Thank you for the opportunity to review the Second (2nd) Traffic Impact Study (TIS) prepared by Lenhart Traffic Consulting, Inc., revised February 14, 2025, for the 16650 Georgia Avenue development (SHA Tracking #24APMO031XX) in Montgomery County, Maryland. The State Highway Administration (SHA) review is complete, and we are pleased to respond.

RE: Preliminary Plan & TIS
Preliminary Plan No. 120250090
Primrose at 16650 Georgia Avenue

Re: **COMBINED STORMWATER MANAGEMENT
CONCEPT/SITE DEVELOPMENT
STORMWATER MANAGEMENT PLAN** for
Primrose at 16650 Georgia Ave – Childcare
Facility
Preliminary Plan #: 120250090
SM File #: 290087
Tract Size/Zone: 2.12 ac. / R-200
Total Concept Area: 1.53 ac.
Lots/Block: N/A
Parcel(s): 110
Watershed: Upper Rock Creek
Redevelopment (Yes/No): Yes

Re: Letter of Findings / WSSC Project No. DA7944Z25, LITTLE STEPS 16650 GEORGIA AVENUE

Fig. 1: Proposed Frontage Condition Per Preliminary Plan 120250090 & Conditional Use CU202504

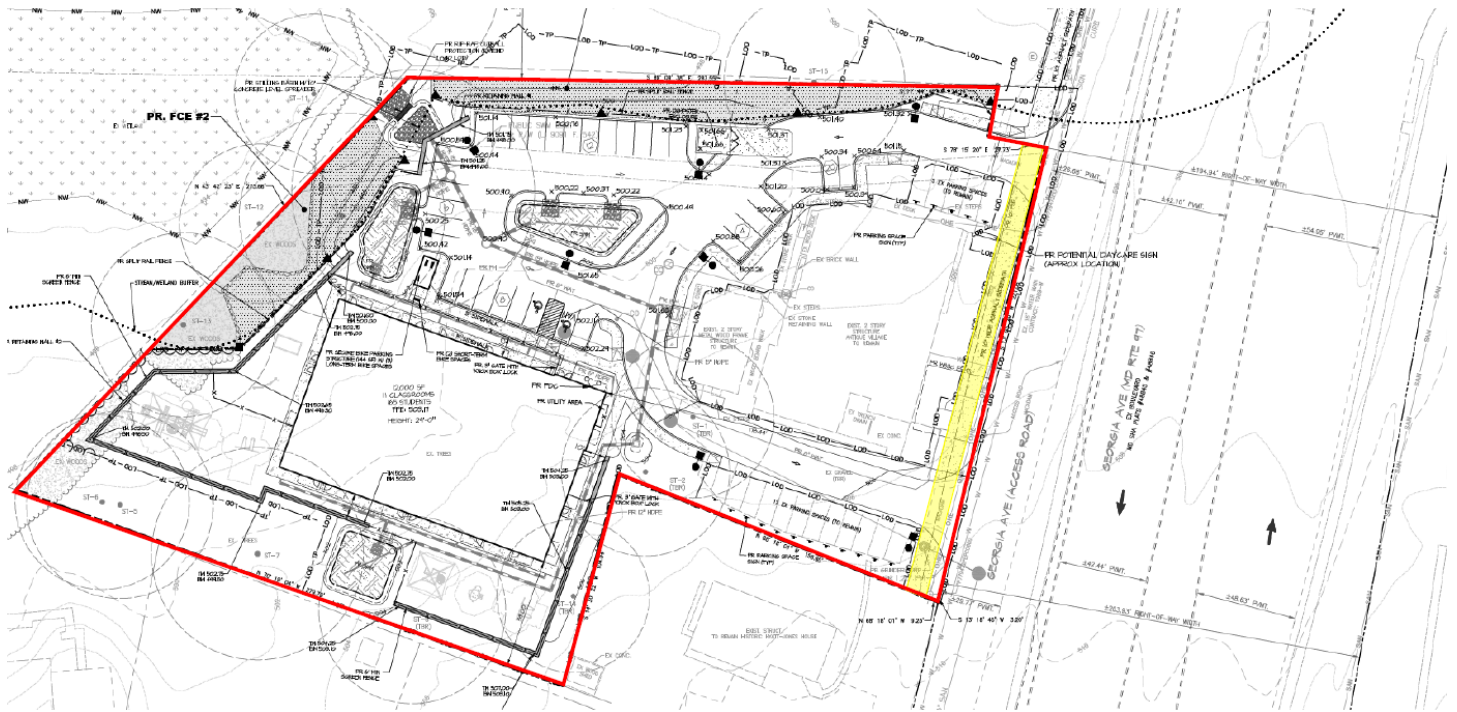
- The existing SHA right-of-way, while variable in width, has a minimum width of 194 feet in the vicinity of the site. Thus, the existing condition already exceeds the Olney Master Plan's recommended width of 150 feet, and no additional dedication is needed to achieve the master plan's transportation recommendations. In fact, as shown in the screenshot of the zoning map below (Fig. 2), the right-of-way is over 200 feet at one point along the property's frontage.

- As noted above, the Applicant is proposing a 10-foot-wide side path that will be placed with a public improvement easement along the property's frontage. The off-site extension of the path on the HOA property to the north will also be placed in a public improvement easement, given that the off-site land is not within the scope of the Preliminary Plan and cannot be dedicated for public use. If SHA were to require dedication from the site and thus assume maintenance obligations for the on-site portion of the path, it would be for only the limited area of the path adjacent to the service road, in an area that is well separated from the primary vehicle lanes on Georgia Avenue. Further, if the path extension to the north is separately maintained by the County, SHA's obligations would be only for a limited segment along the front of the site. This outcome seems both complex and inefficient for such a small project and portion of the path.

I discussed internally, and we would accept a P.I.E. in lieu of dedication.

Fig. 2: Zoning Map Excerpt Showing Approximate Existing ROW Width

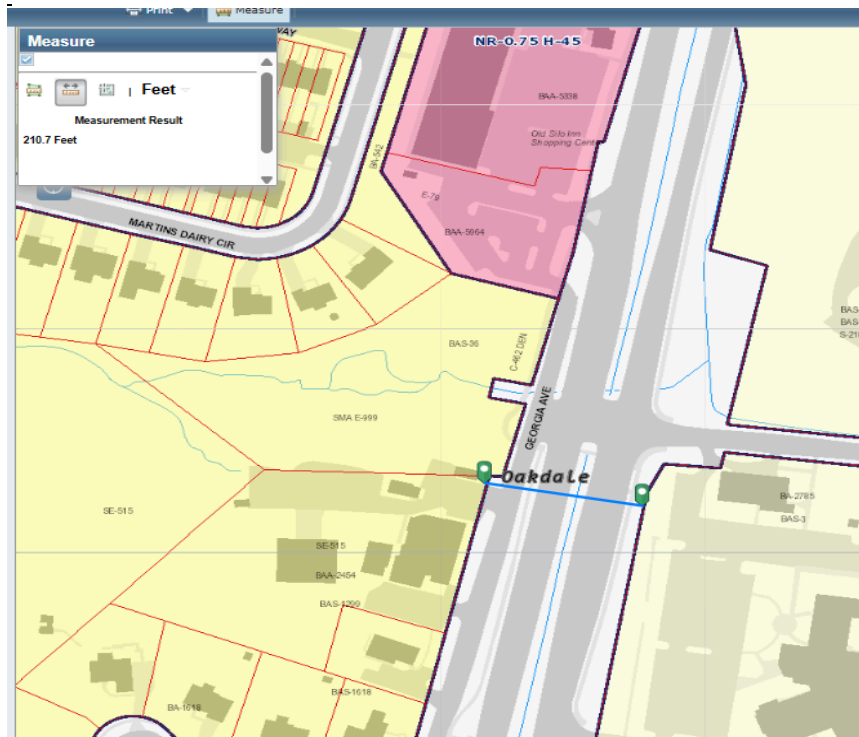
- It appears from the screenshot below that right-of-way widths along the site's frontage also exceeds those of the two properties to the north, including the retail center at 16800 Georgia Avenue. The retail center was platted in approximately 1982 and dedicated land along its frontage to achieve the existing condition. The property located immediately adjacent to the site serves as HOA open space. Neither property is likely to undergo resubdivision in the foreseeable future and, thus, additional dedications are anticipated from those sites to match the existing conditions on the site's frontage, or any additional dedications that could be required.

FIRE DEPARTMENT ACCESS PLAN

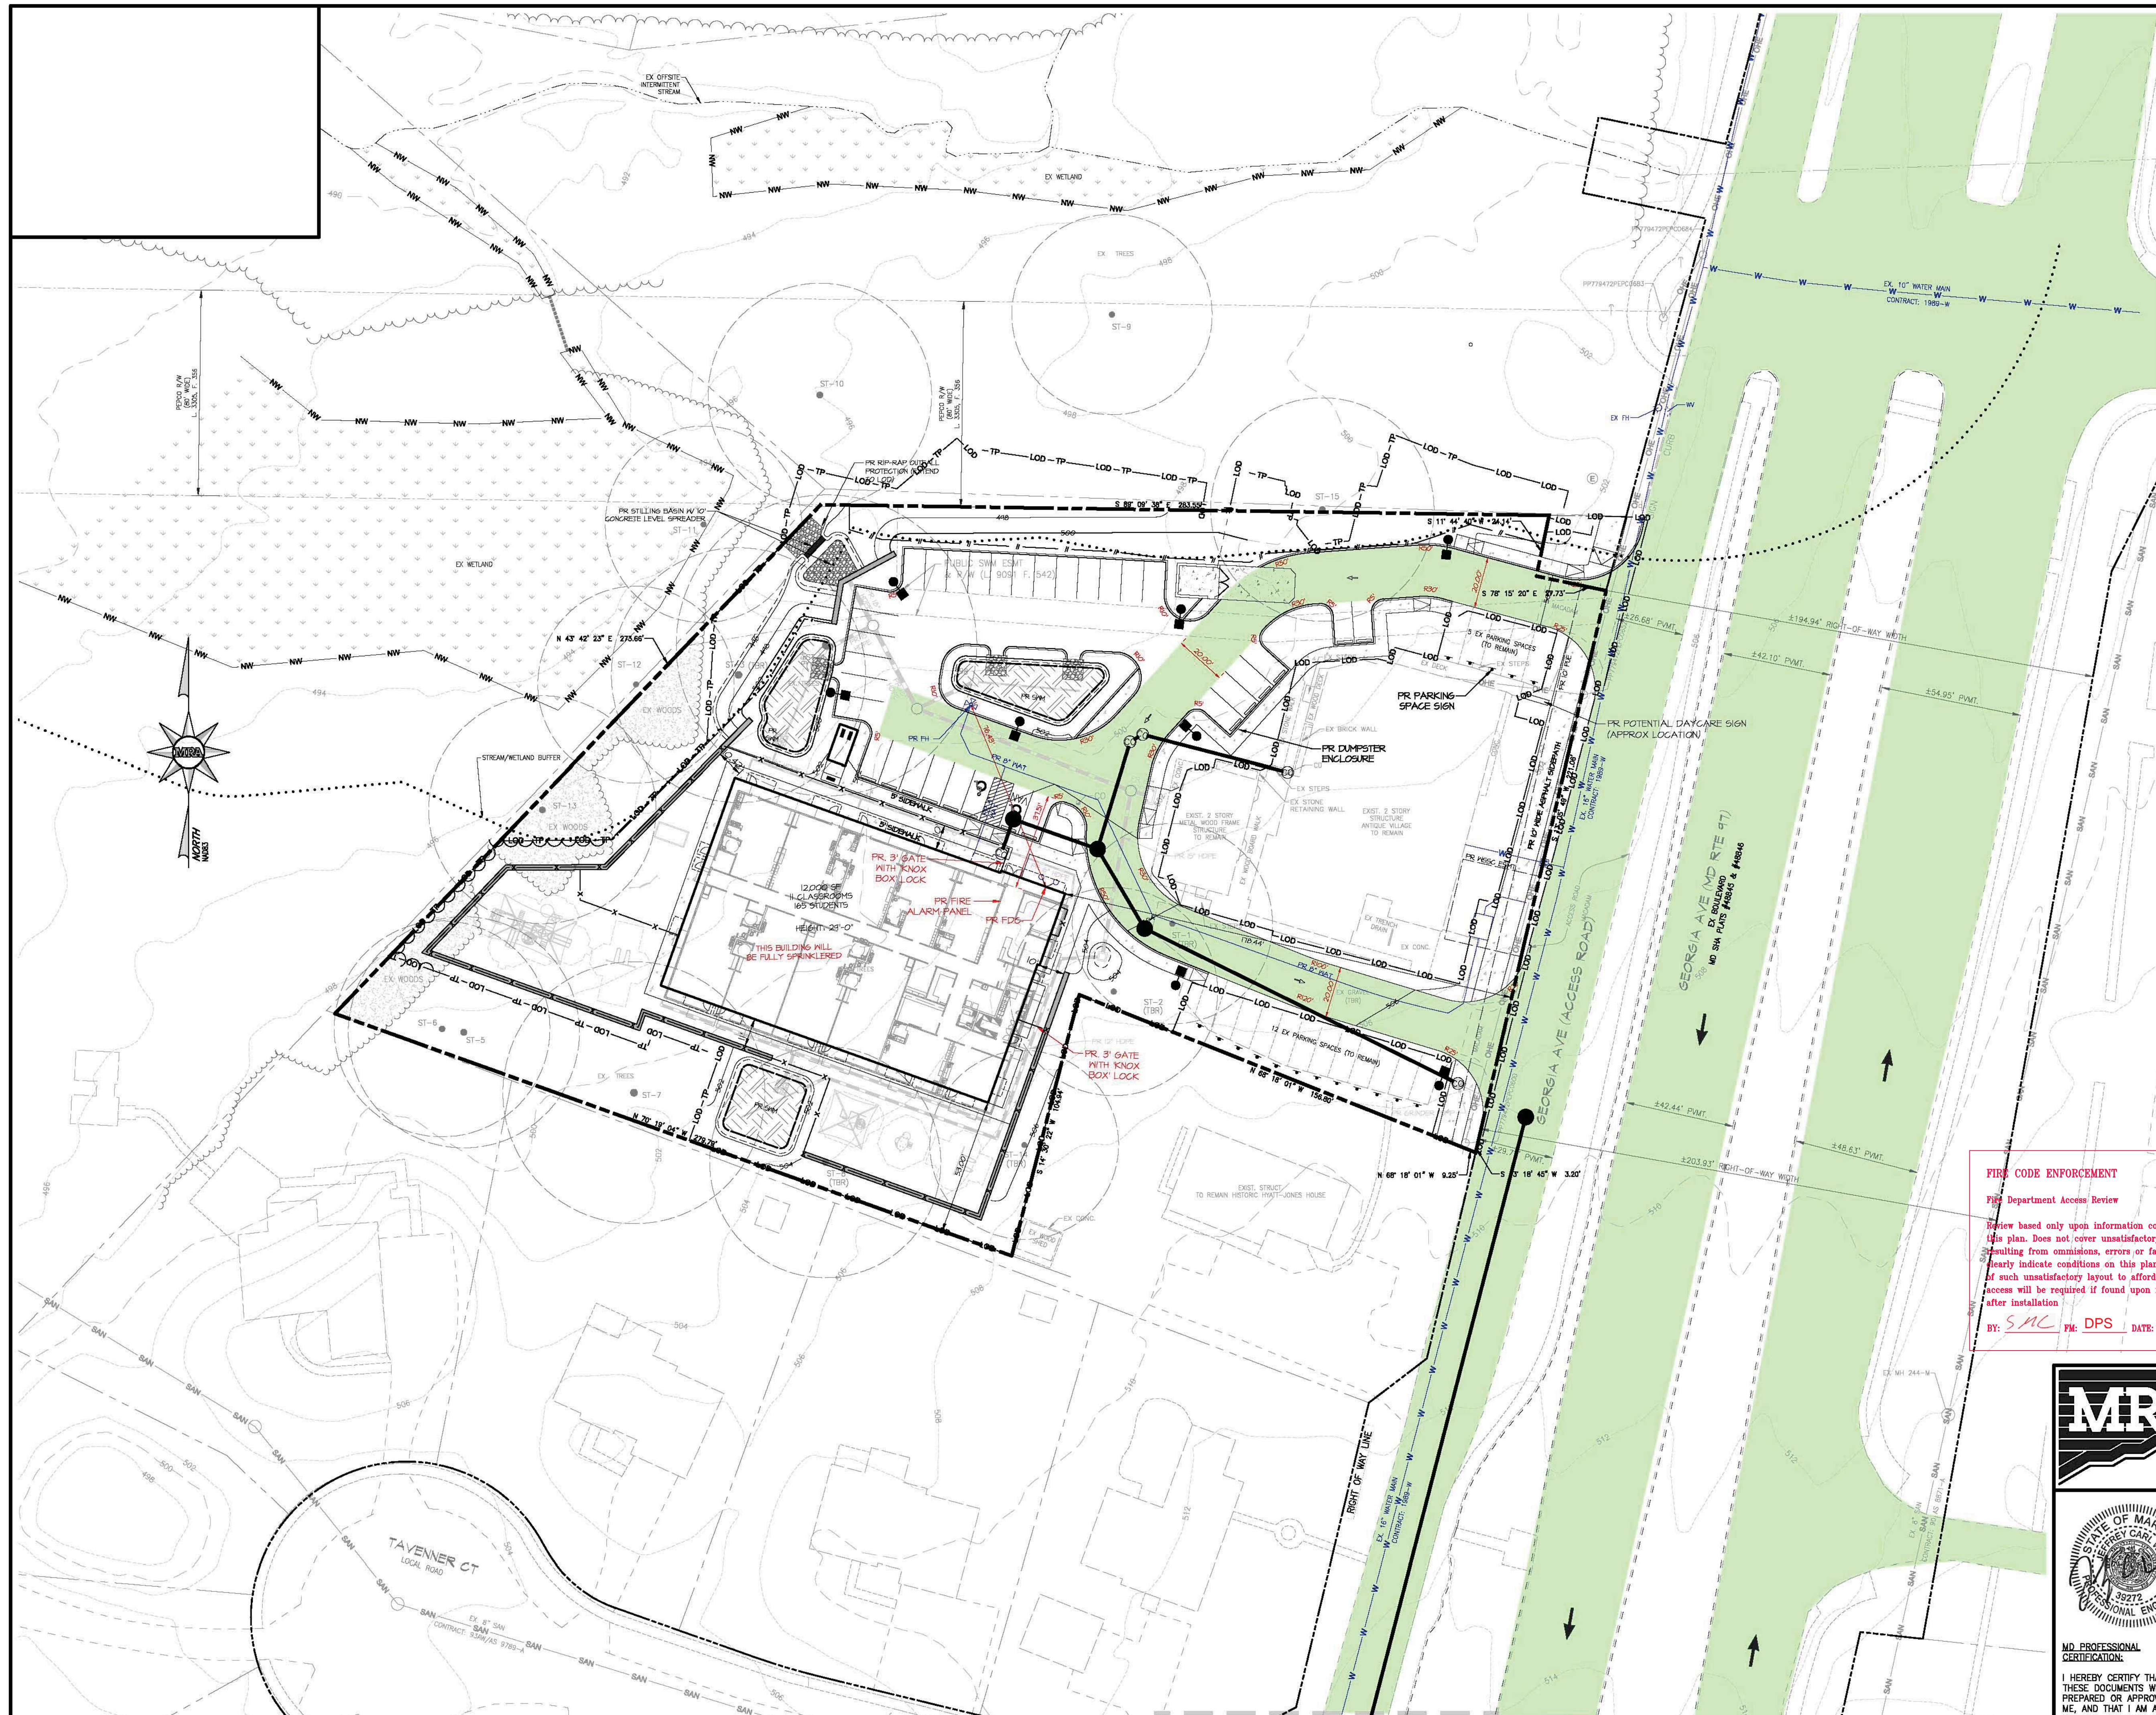
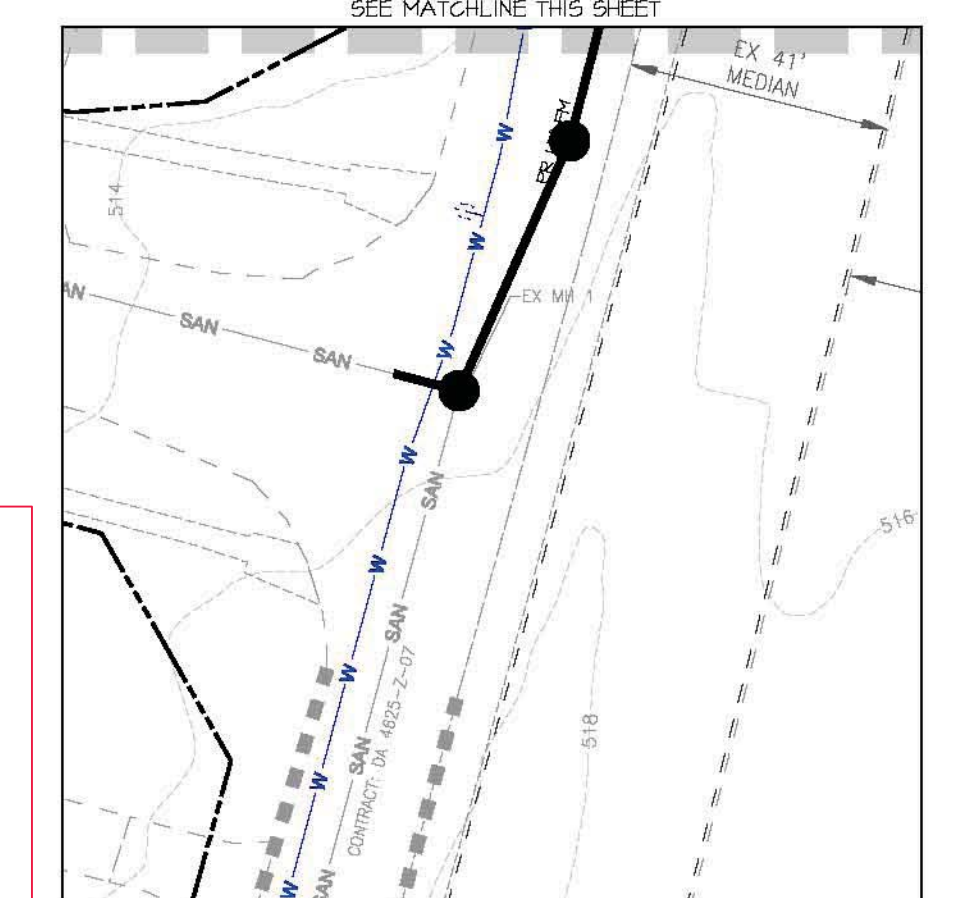
PLAN APPROVED

1. Review based only upon information contained on the plan submitted **18-Mar-25**. Review and approval does not cover unsatisfactory installation resulting from errors, omissions, or failure to clearly indicate conditions on this plan.
2. Correction of unsatisfactory installation will be required upon inspection and service of notice of violation to a party responsible for the property.

FIRE CODE ENFORCEMENT
 Fire Department Access Review
 Review based only upon information contained on this plan. Does not cover unsatisfactory layout resulting from omissions, errors or failure to clearly indicate conditions on this plan. Correction of such unsatisfactory layout to afford required access will be required if found upon inspection after installation.
 BY: SMC FM: DPS DATE: 3/19/2025

HYDRAULIC PLANNING ANALYSIS
 PRIMROSE AT 16650 GEORGIA AVENUE

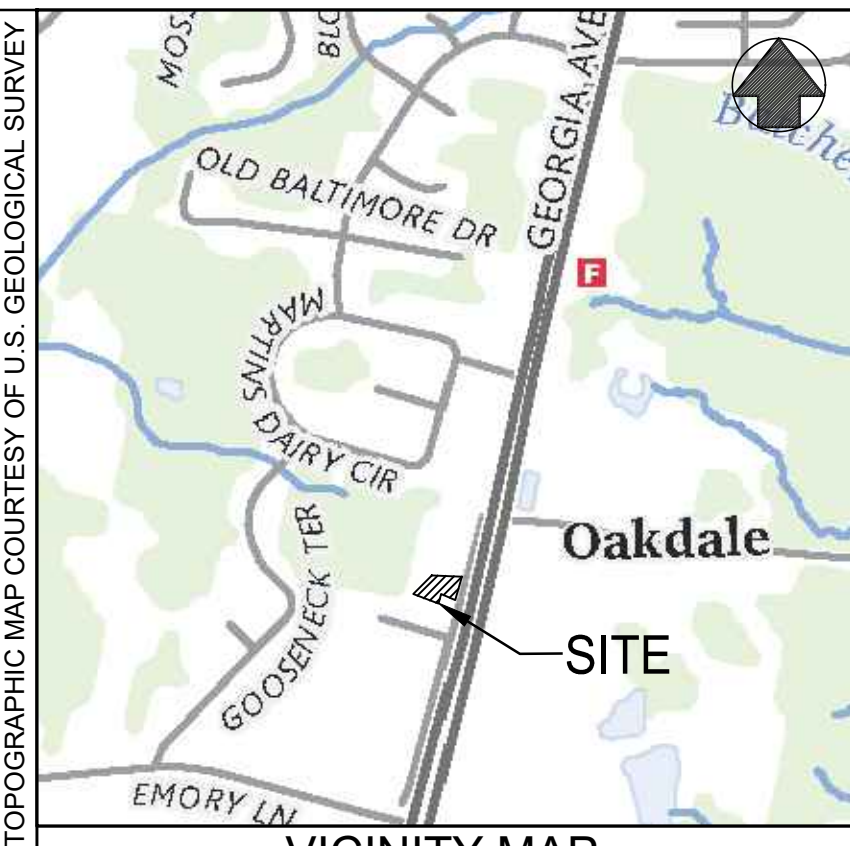
All proposed gravity sewer mains are to be 8-inch sewer mains at minimum slope are shown on the attached sketch.

Based on the proposed grading plan, ejector or grinder pump(s) and on-site low-pressure sewer are required for service. A registered plumber must install the pumps at the developer's expense.

An existing water main is available to provide service to this project. Water service may be obtained by constructing service connections without a public extension.
